Trojan Nuclear Plant
Docket 50-344
License NPF-1

Attached please find the supplemental information regarding the Trojan Nuclear Plant Auxiliary Feedwater (AFW) System, which specifically responds to Items B.2 and C.6 in the enclosure to your letter of May 14, 1980. This submittal will complete the requested PGE responses to the aforementioned NRC letter.

Trojan Nuclear Plant PGE Supplemental Response to the May 14, 1980 NRC Request on the Auxiliary Feedwater System

Figure 1 Trojan Nuclear Plant
 AFW Pump 48-Hour Endurance Test
 Flow Schematic Diagram

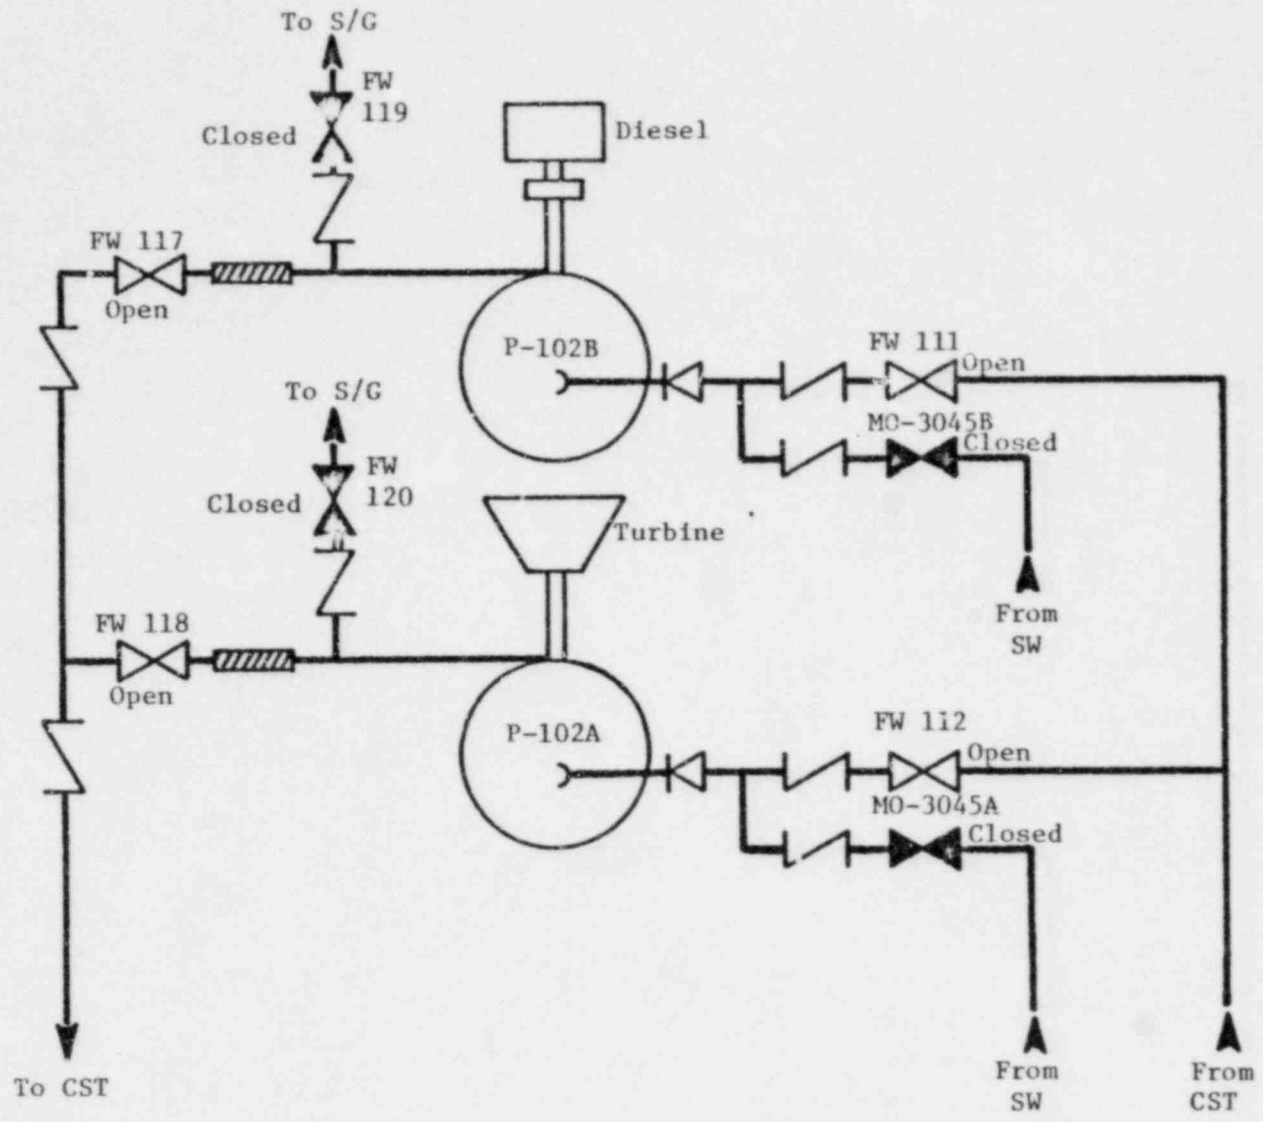
The licensee indicates that the AFW pump/driver vendor strongly discourages performance of an endurance test. It is our position that you perform an endurance test for each AFW pump prior to startup of Cycle 3 in accordance with the attached revised Additional Short-Term Recommendation No. 2. Note that the test requirement has been reduced from 72 hr. to 48 hr. The licensee should commit to follow the provisions of the revised AFW pump endurance test requirements and submit the requested test information.

As we indicated in the July 1, 1980 PGE letter, the 48-hr. endurance tests had been conducted, prior to startup of Cycle 3, on turbine-driven and diesel-driven Auxiliary Feedwater (AFW) pumps in accordance with the testing conditions specified in the enclosure to the May 14, 1980 NRC letter. The tests were run in the AFW recirculation line at rated pump speed of 4560 RPM with a reduced flow of 80 gpm and a discharge pressure of approximately 1750 psig for the turbine-driven pump and approximately 1580 psig for the diesel-driven pump. After the 48-hr. test run, the pumps were secured for longer than 8 hr. and allowed to cool down to within 20°F of their start-up temperatures. The pumps were then restarted and kept running for an additional 1 hr.

Figure 1 provides the flow schematic diagram for the test. The AFW pump/driver bearing temperatures measured by thermocouples were recorded on strip chart recorders and the plots of the results are presented in the attached Figures 2 and 3. At each bearing, the vibration data were taken at horizontal, vertical and axial directions. Figures 4 and 5 (attachments) provide ambient temperature and humidity data in the pump rooms which were also measured during the tests.
